**From:** Dawson, Kevin <Kevin.Dawson@yvw.com.au>  
**Sent:** Wednesday, 24 June 2020 2:58 PM  
**To:** Ben Champion  
**Cc:** Brooke, Nick; Gibb, Lauren; O'loughlin, Rosie; Fittock, Robert; Patrick, Paul  
**Subject:** RE: Yarra Ranges C193 - initial comments  
**Attachments:** image007.emz; image011.emz

Thank you for the opportunity to provide initial feedback on the proposed Yarra Ranges Planning Scheme Amendment C193 (Lilydale Quarry Redevelopment)

**Figure 5 – Potable Servicing Strategy – Stage 1**

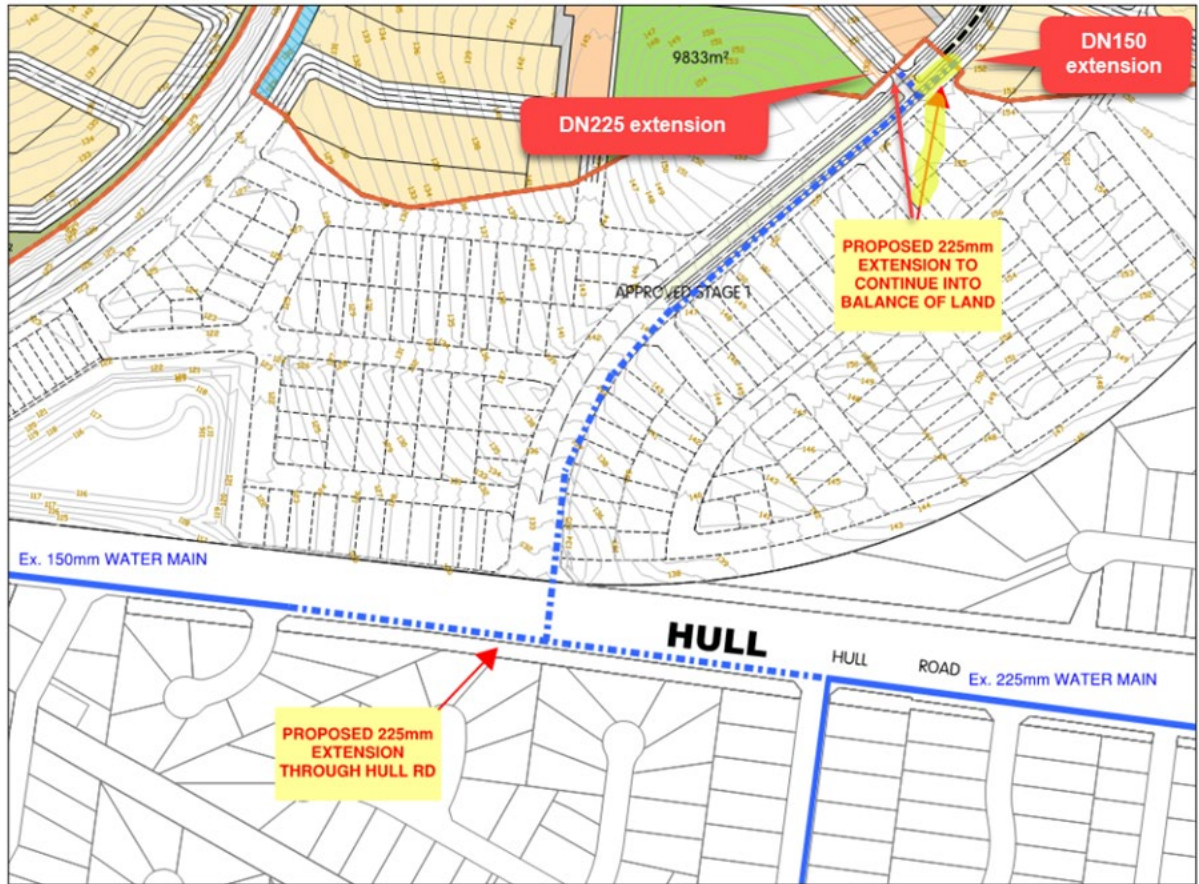
The proposed DN255 will not continue north as shown in Figure 5.

The proposed DN225 alignment will run west to cross the train line, through the estate to Mooroolbark Rd and then north to Maroondah Hwy, connecting to the Plantes Hill WDZ network near the intersection of Maroondah Hwy and Mooroolbark Rd (DN450 MS main on the north side of Maroondah Hwy).
